**P.O.A.D.P. FOR REDWOOD BUSINESS PARK**

Re: Redwood Business Park

POADP # 620

The City Staff Development Review Committee has reviewed Redwood Business Park Subdivision Preliminary Overall Area Development Plan # 620. Please find enclosed a signed copy for your files. Although your plan was accepted, please note the following:

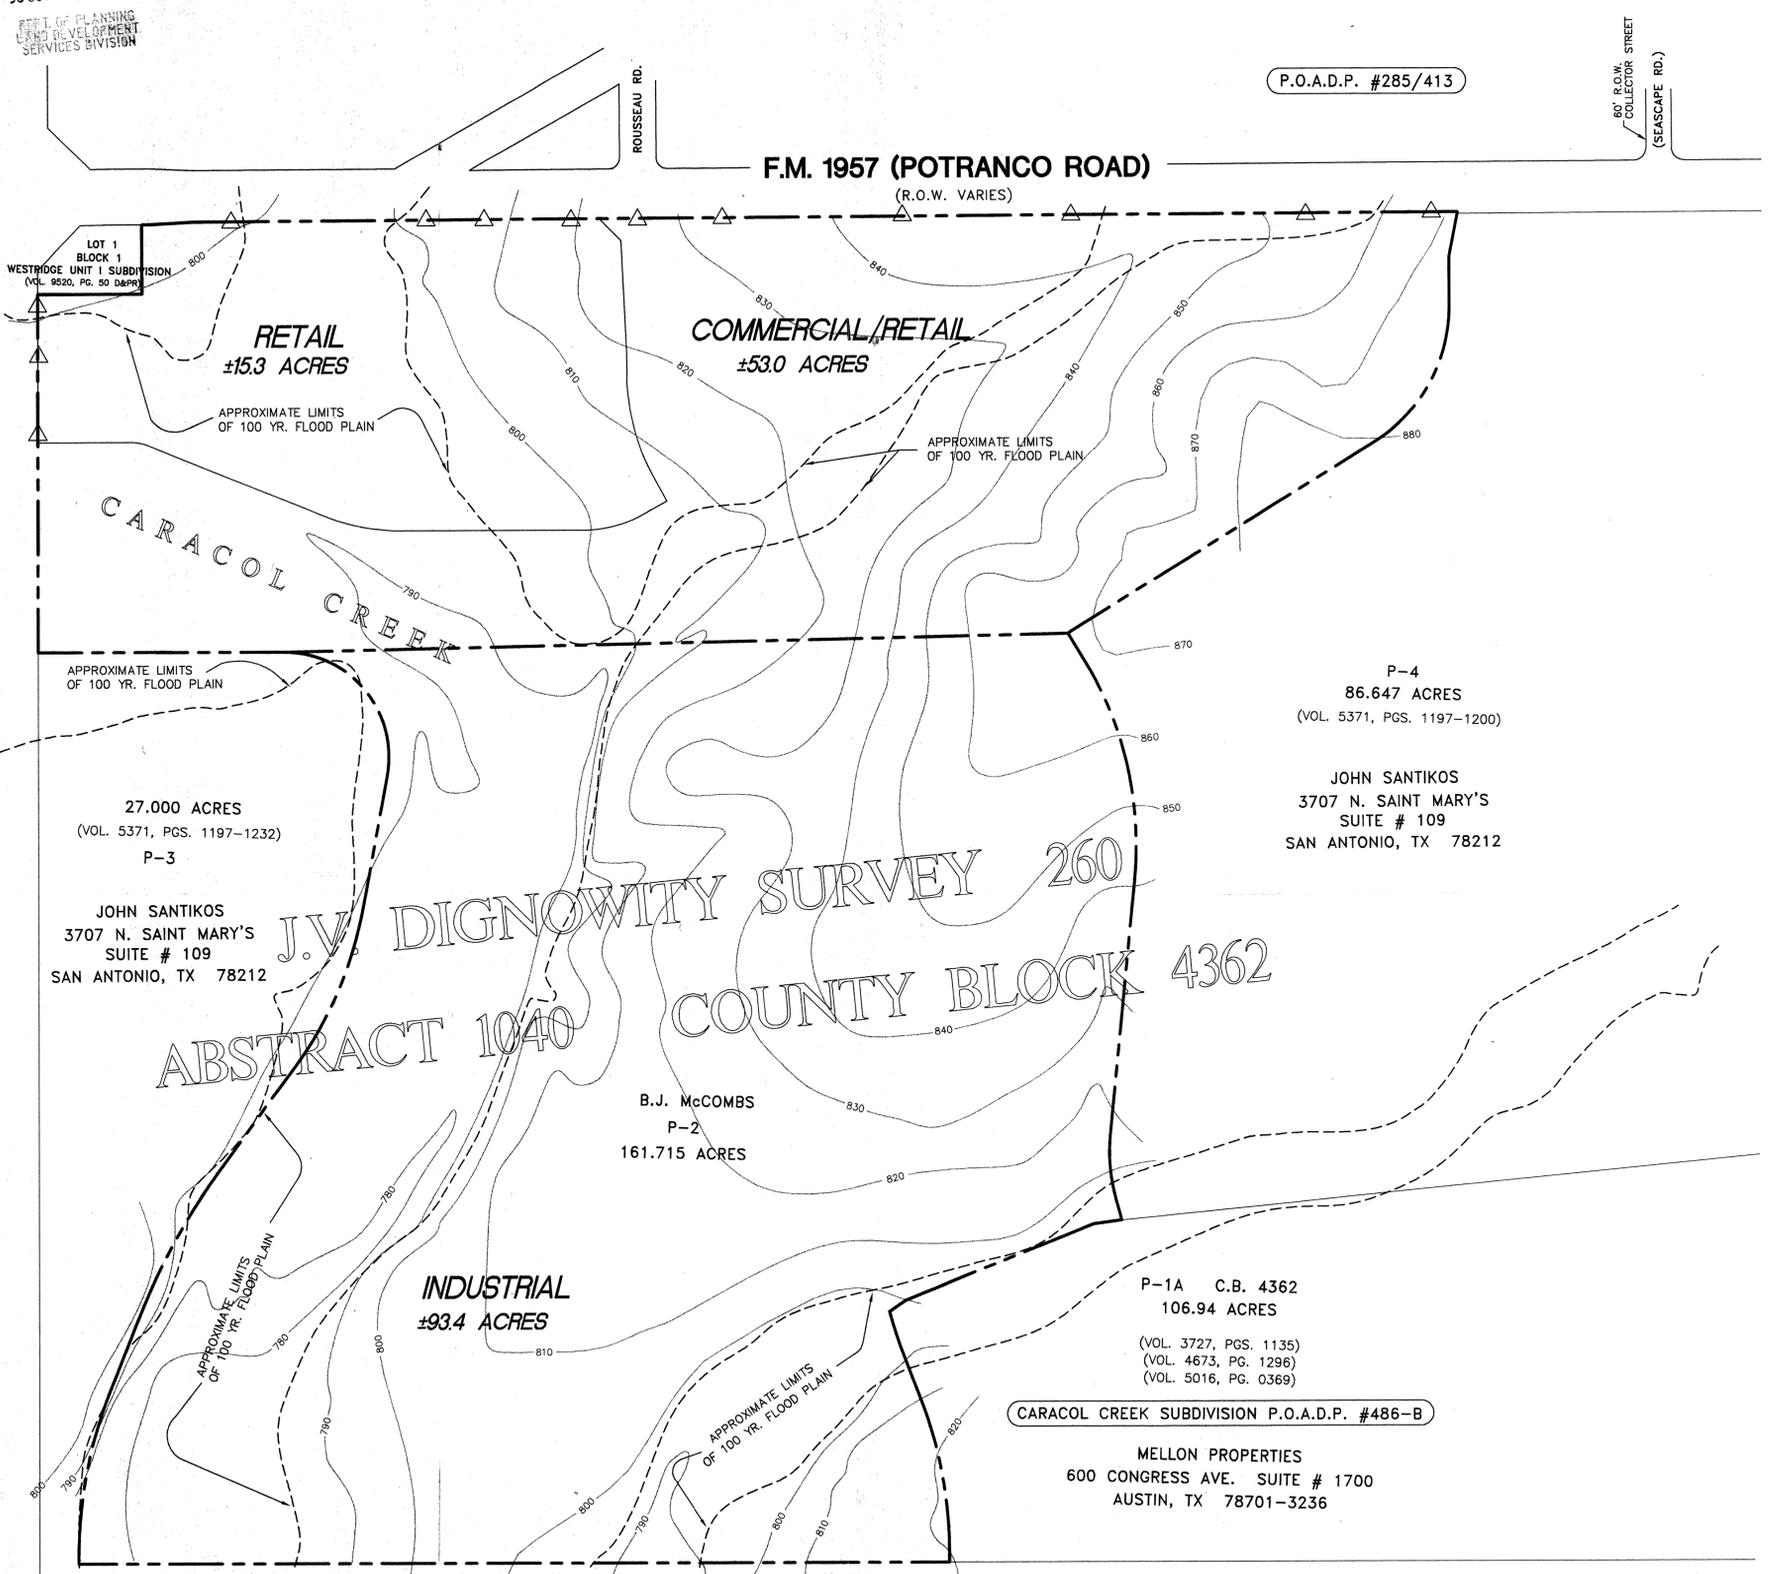
- Based on the topography, a Flood Plain Study and drainage review will probably be required during the platting process.
- Access and R.O.W. issues along State facilities will need to be resolved with the Texas Department of Transportation (TXDOT). For information about these requirements you can contact TXDOT at 615-5814.
- This development will need to comply with tree preservation ordinance #85262. For information about these requirements you can contact Building Inspections at 207-7102.
- It will be expected that you will plat all of the property depicted in your POADP, to include: floodpains, drainage areas and open space.
- I would encourage you to work closely with the school district, so that they can plan accordingly.
